### **REMARKS**

### Amendments to the Drawings

The attached replacement Figs. 5, 6, 11a, 12a, 12b, 13a, and 14c have been revised to correct various informalities. These sheets replace the original Figs. 5, 6, 11a, 12a, 12b, 13a, and 14c. A corresponding set of red-lined drawings of Figs. 6, 11a, 12a, 12b, 13a, and 14c is also attached. The changes are discussed in the remarks section below.

Fig. 5

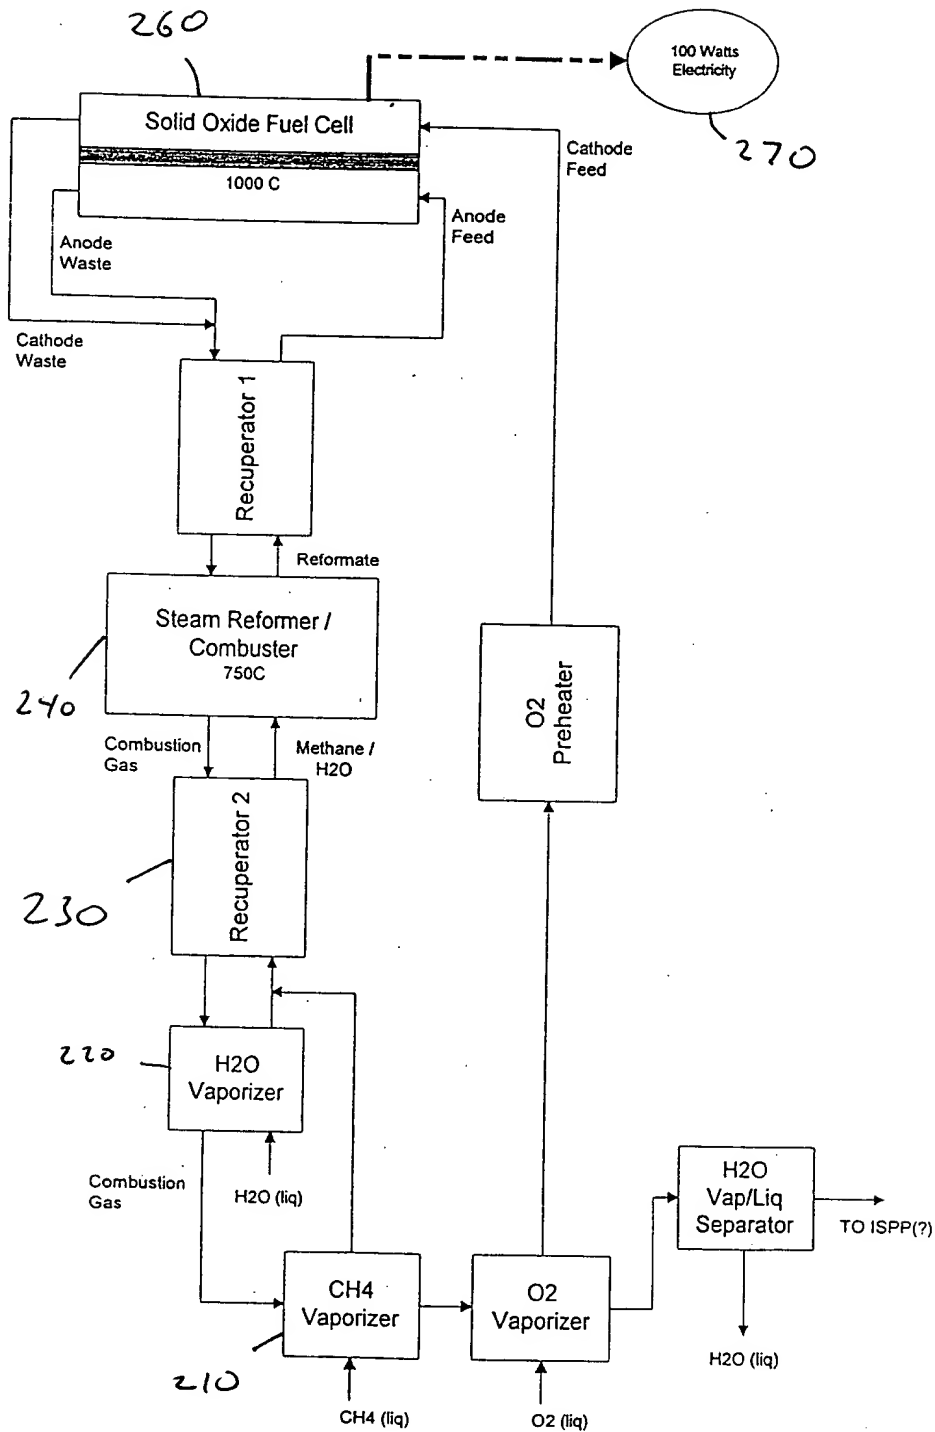
Figs. 5 and 6 have been amended as suggested by the Examiner. For Fig. 10, the labels 101, 138, 140, and 134 have been added to the specification. In Figs. 12a and 12b A and B shims are now labeled. The specification has been amended to add "1000." The labels 180, 182, 184, and 186 have been deleted from Fig. 13. In Fig. 14c, 202 has been added; "228" has been deleted from the specification.

Fig. 11a

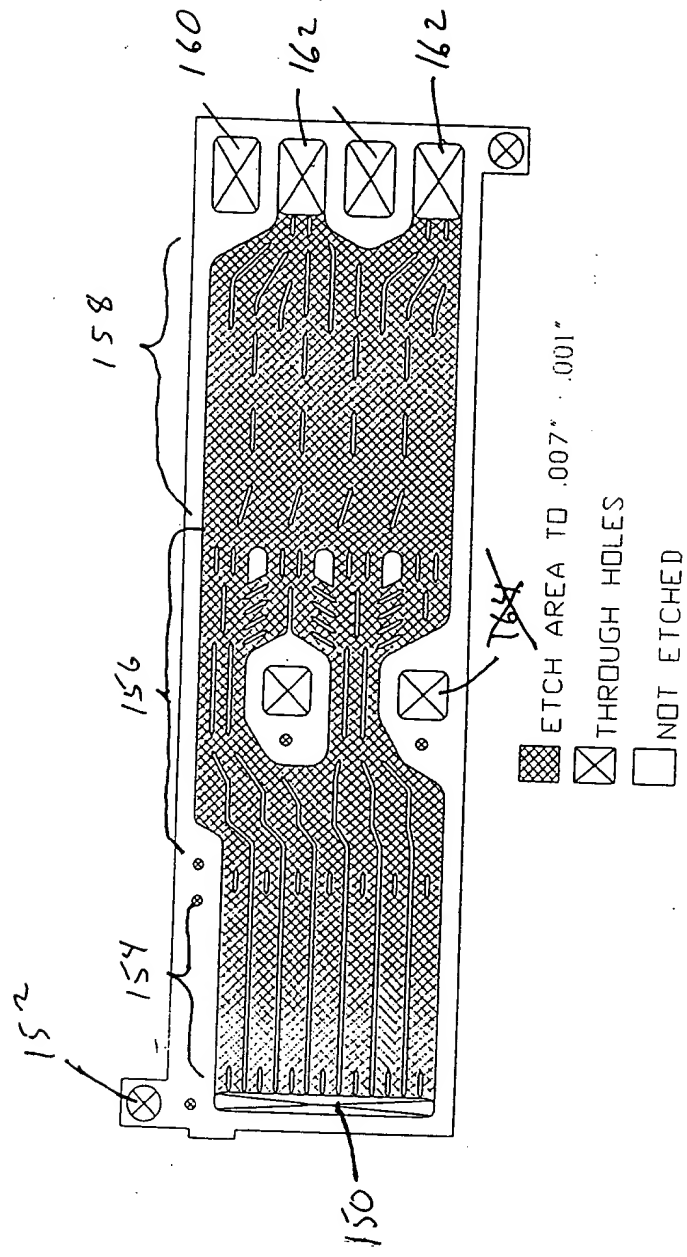
In Fig. 11a and 11b, "164" was deleted and "172" was added to the specification. The specification (p 31, line 12) has also been amended to reference "360."
